## Product Change Notice (PCN)

PCN Number: **PCN-0451100R-02**

Product(s) Affected: SJD1-3201-54

<p>Recommended PCB Layout Top View</p>	 <p>Recommended PCB Layout Top View</p>

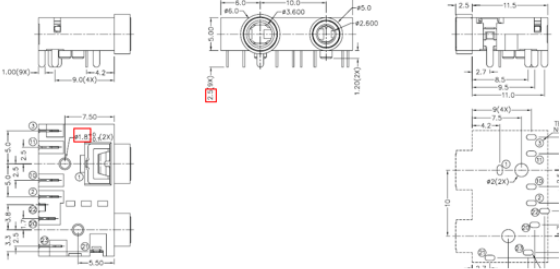
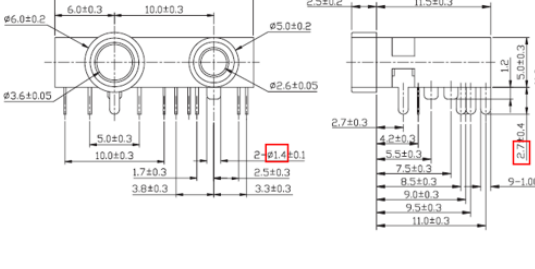
Description of Change: mechanical and material differences as shown below:

MATERIAL	PLATING
terminal 1	copper alloy	tin
terminal 2	copper alloy	tin
terminal 3	copper alloy	tin
terminal 10	brass	tin
terminal 11	brass	tin
terminal 20	brass	tin
terminal 21	copper alloy	tin
terminal 22	copper alloy	tin
terminal 23	copper alloy	tin
bushing	brass	nickel
plastic	PBT

DESCRIPTION	MATERIAL	PLATING/COLOR
terminal 1	copper alloy	tin
terminal 2	stainless steel t=0.20	tin
terminal 3	stainless steel t=0.20	tin
terminal 10	brass t=0.40	tin
terminal 11	brass t=0.40	tin
terminal 20	brass t=0.40	tin
terminal 21	phosphor bronze t=0.30	tin
terminal 22	stainless steel t=0.20	tin
terminal 23	phosphor bronze t=0.25	tin
bushing	copper alloy	nickel
housing	PAB6+GF15% (UL94HB)	black
